UNITED STATES PATENT AND TRADEMARK OFFICE

10/539,045

Office Action Summary	Application No. 10/539,045	Applicant(s) ULIN ET AL.	
	Examiner DENNIS M. WHITE	Art Unit 1797

DETAILED ACTION

Fig. 8

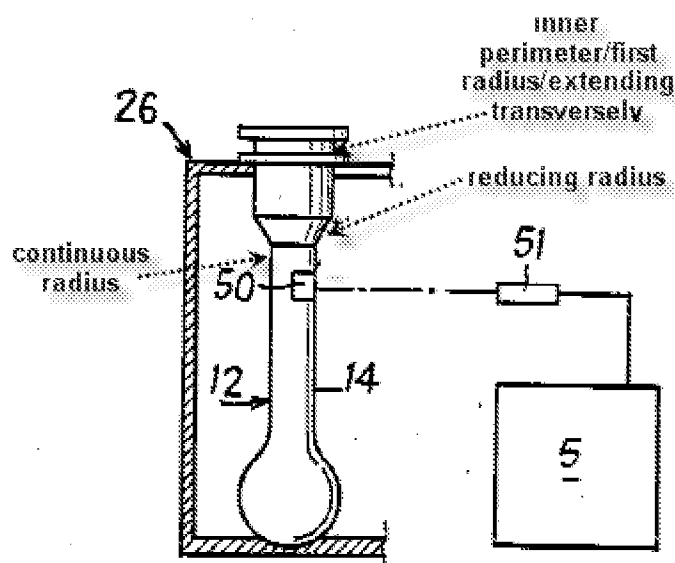
Regarding claims 20-21, Commarmot/Jennings the container has a rim that extends to the diaphragm, sealing the open end of the vessel wherein a reducing radius portion smoothly transforming into a portion of continuous radius defining a reaction chamber of the verse cavity. Commarmot further shows container 12 wherein the upper rim extends transversely (see Fig. 8 below).
